15 May 2020

Edition 10

# AUSTRALIAN NOTICES TO MARINERS

## Notices 361 - 406

*Note for chart Aus 301*

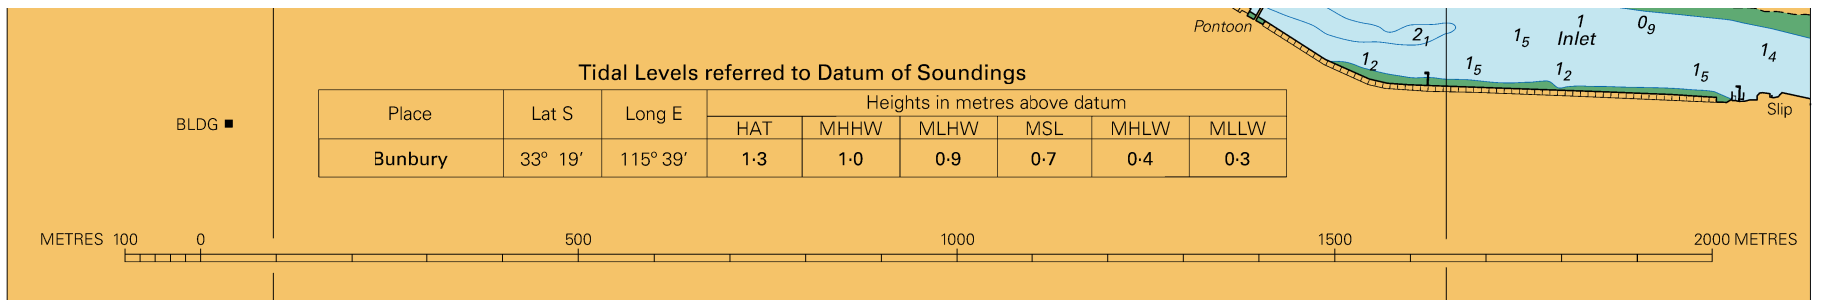
*To accompany Australian Notice to Mariners 368/2020*

ESTUARY AND RIVER ENTRANCES

The crossing of coastal bars and entry to rivers and estuaries is potentially dangerous. Bars and entrances are dynamic in nature, hence the depth and preferred approach may vary. Leading beacons and other navigational aids may not always indicate the best approach. If mariners are unsure of the condition at a particular bar or entrance, local information should be sought prior to crossing.
